University of Lincoln
Centre of Excellence

Proposed Roof Plan
(Planning)

M00439 - PEV - V1 - 02 - DR - A - 9004

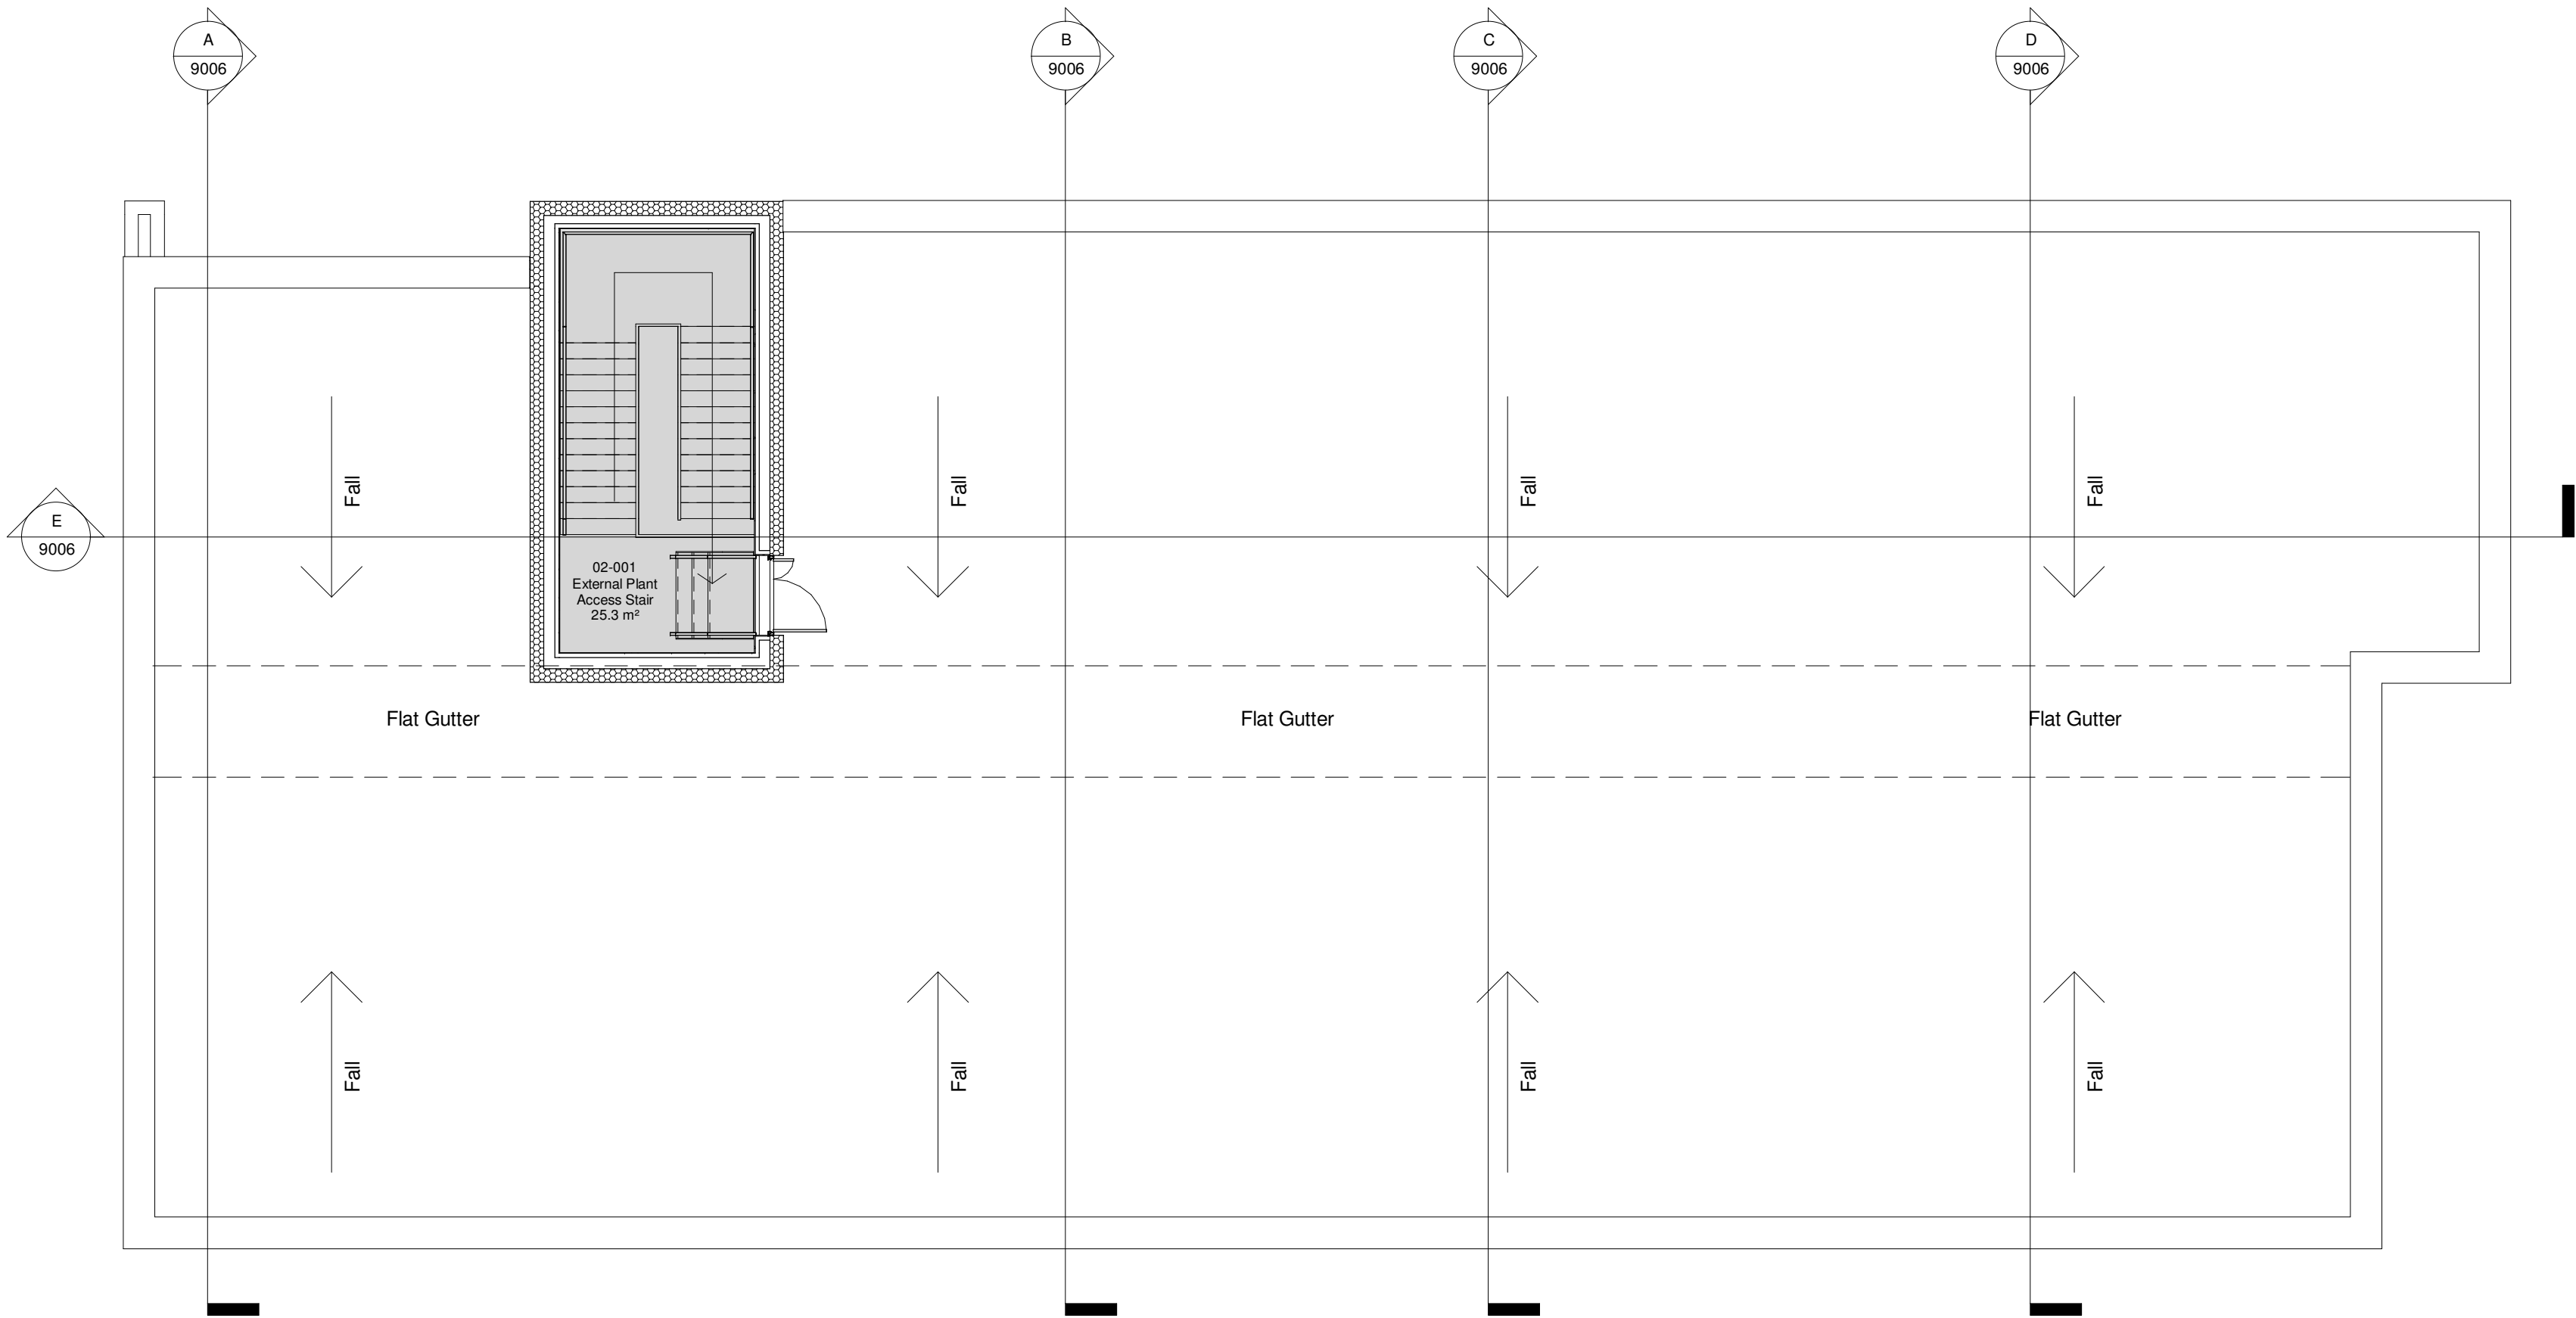
P02	Timber cladding and timber plant roof enclosure omitted/ building overall length reduced/ Extent of curtain walling reduced/ Submitted for Planning approval	29.08.19	PAH	DPA
P01	Issued for Planning	29.02.18	RJT	DMS
Revision		Date	Drn	Chk
This document references the following files:-				
Reference Name		Status	Revision	
M00439-01-ZZ-M3-A-0001		S1	P03
